PTS STANDARDS - 100 SERIES DRAWINGS
STANDARDS FOR ROADWAY CONSTRUCTION
APRIL 2022 EDITION – CHANGE NO. 2 – NOVEMBER 2023

PTS – 100 SERIES DRAWINGS

PENNSYLVANIA TURNPIKE COMMISSION
INDEX OF STANDARDS FOR ROADWAY CONSTRUCTION

PTS-113

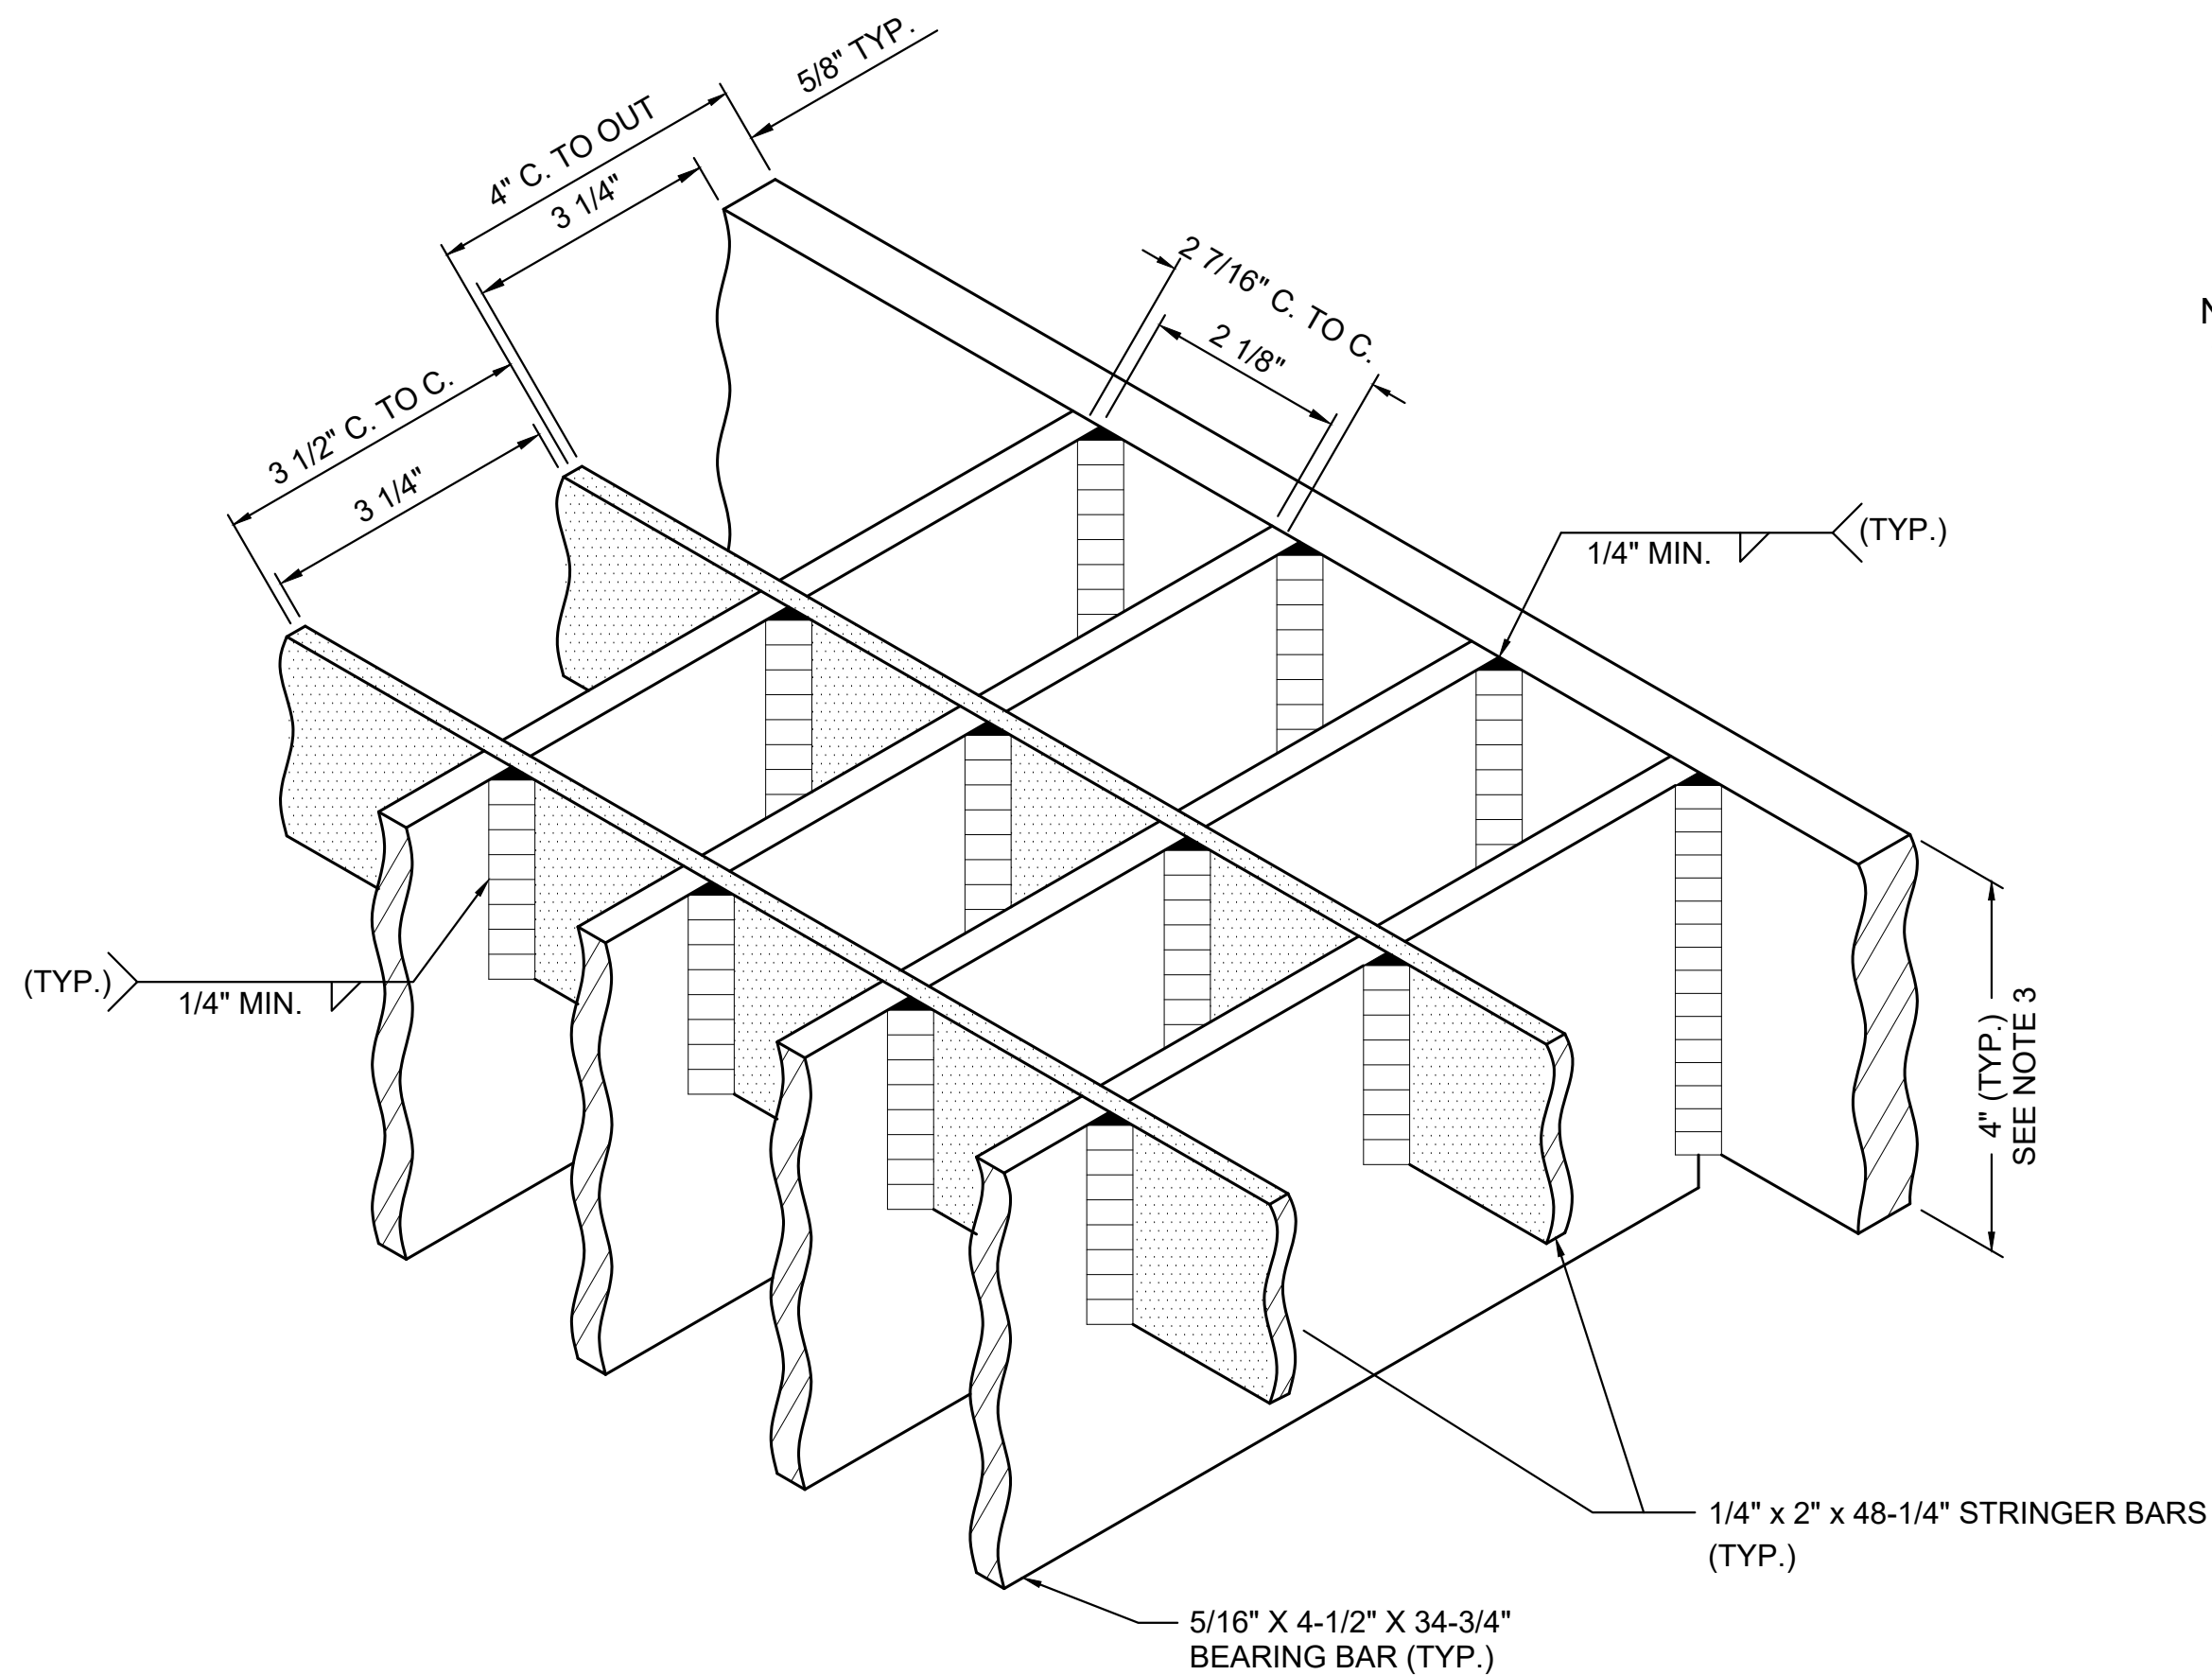
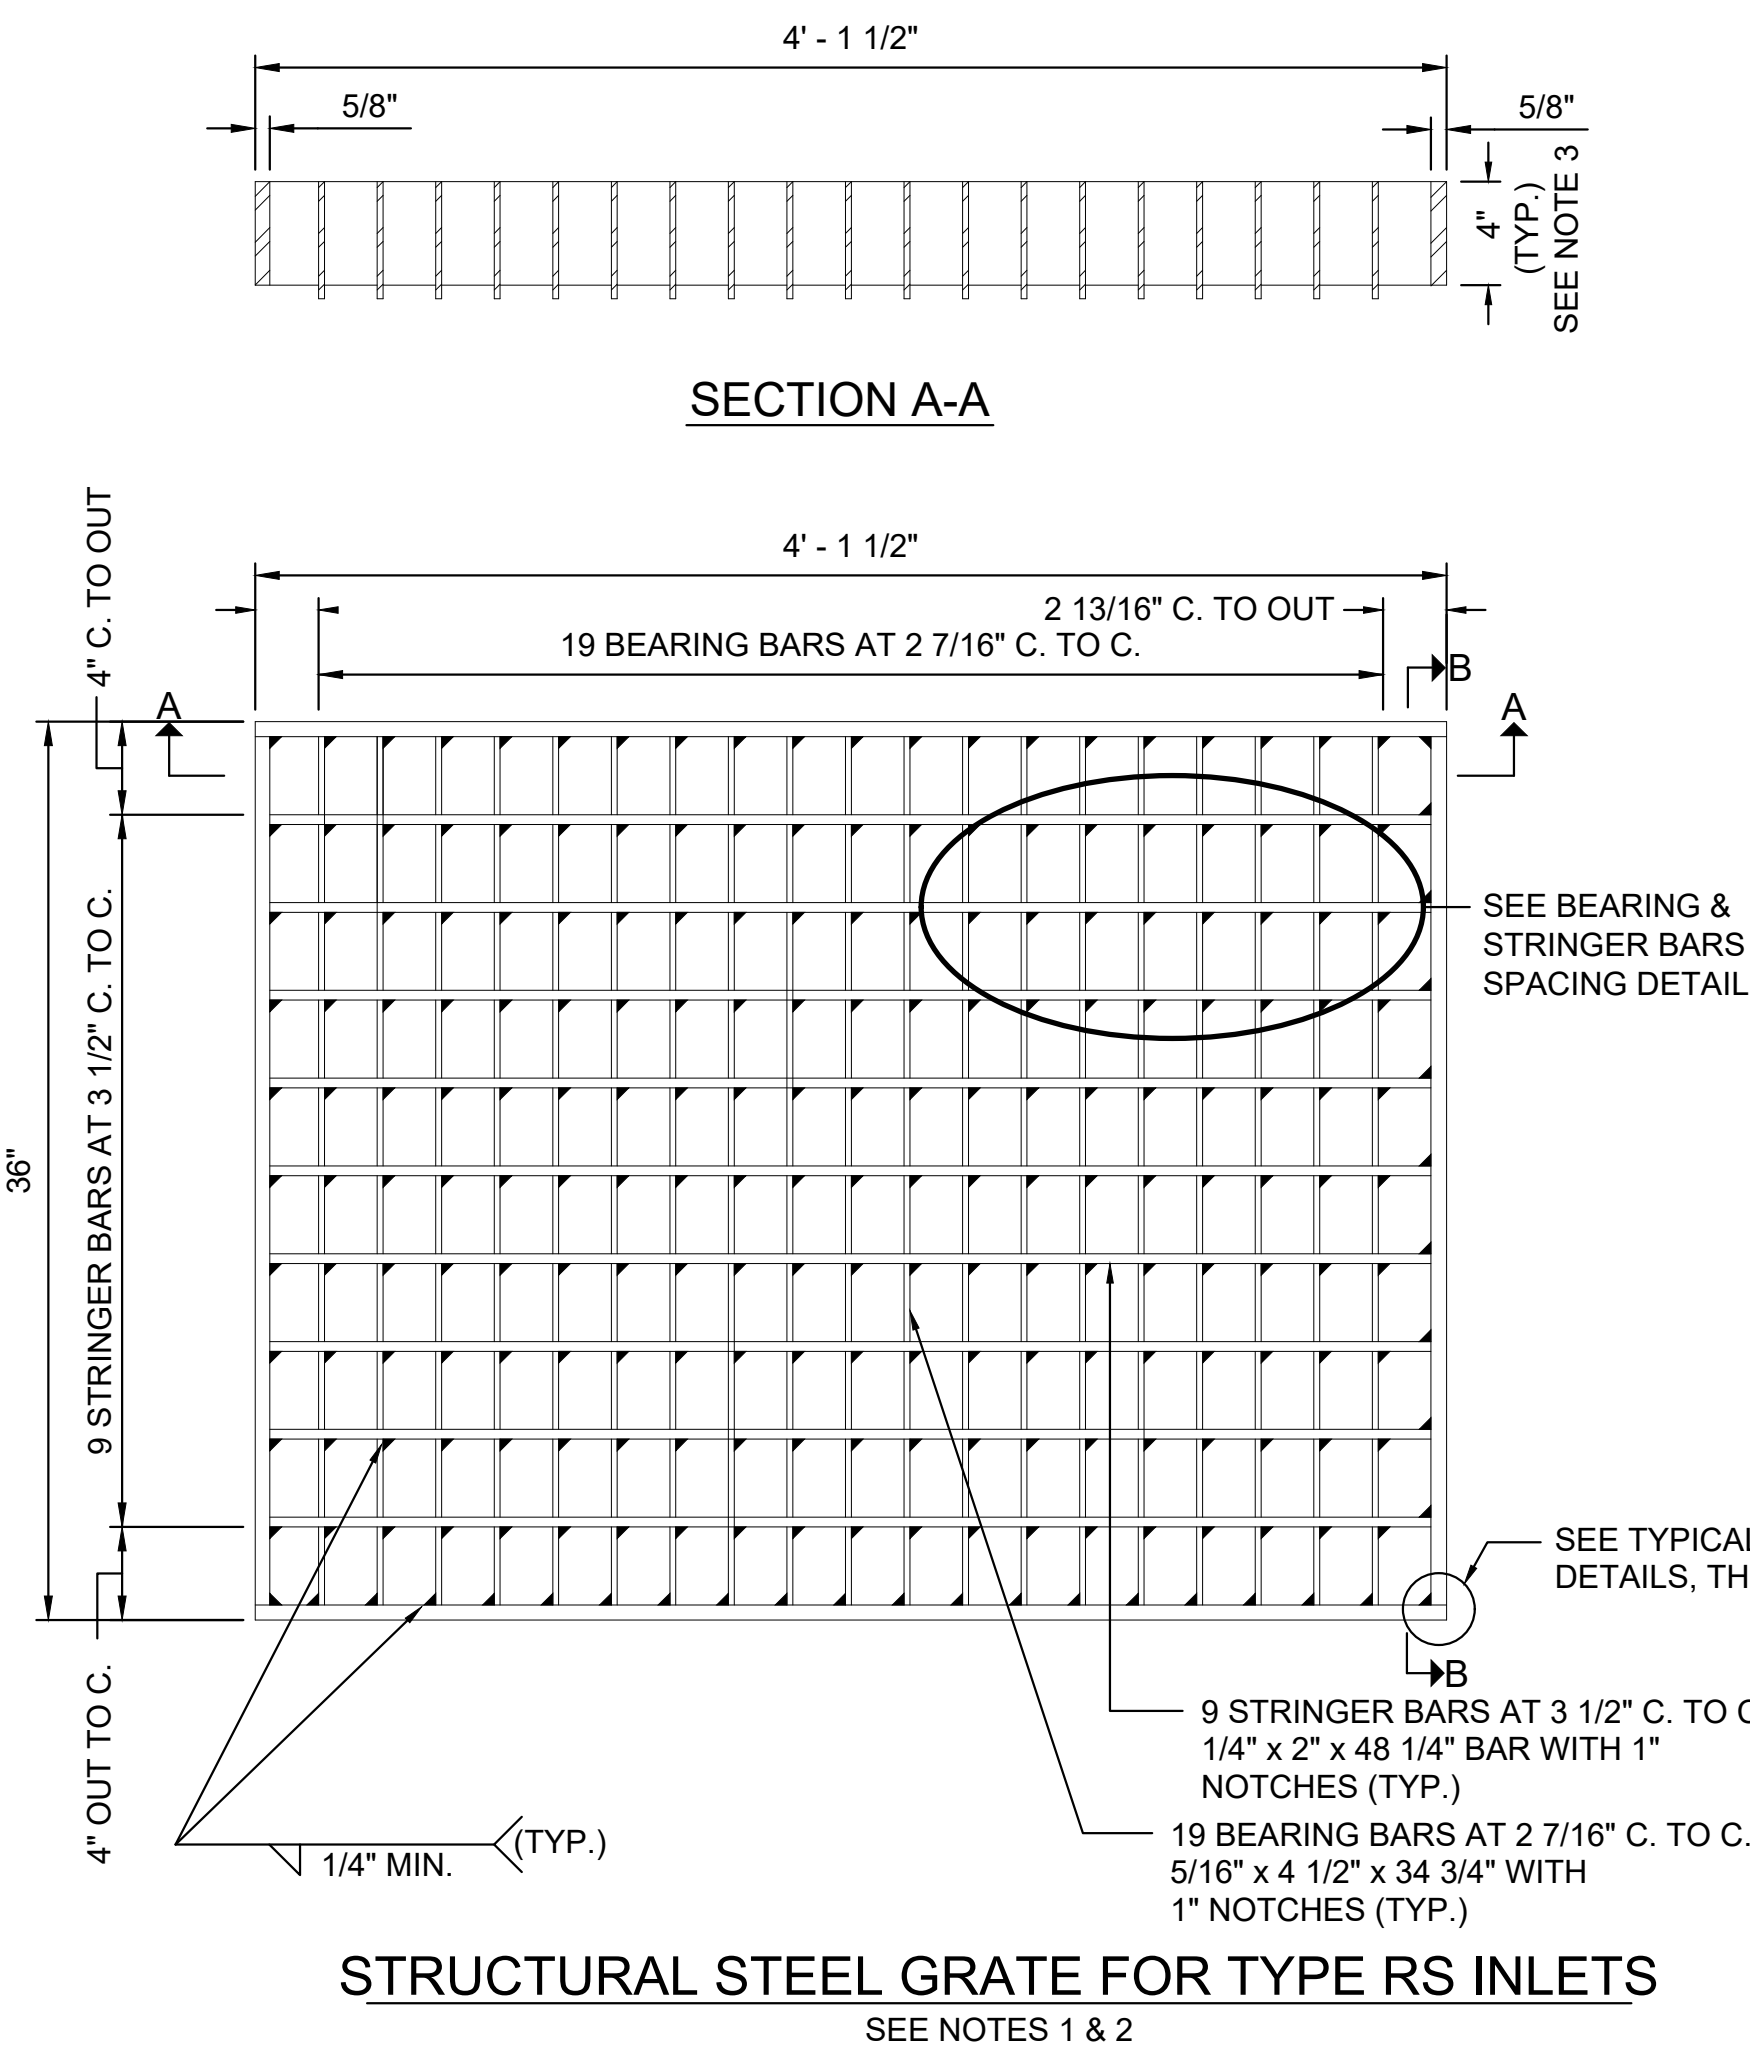
REVISED SPELLING CORRECTION “TRANSVERSE”.
REPOSITIONED THE LOCATION OF THE NOTES.
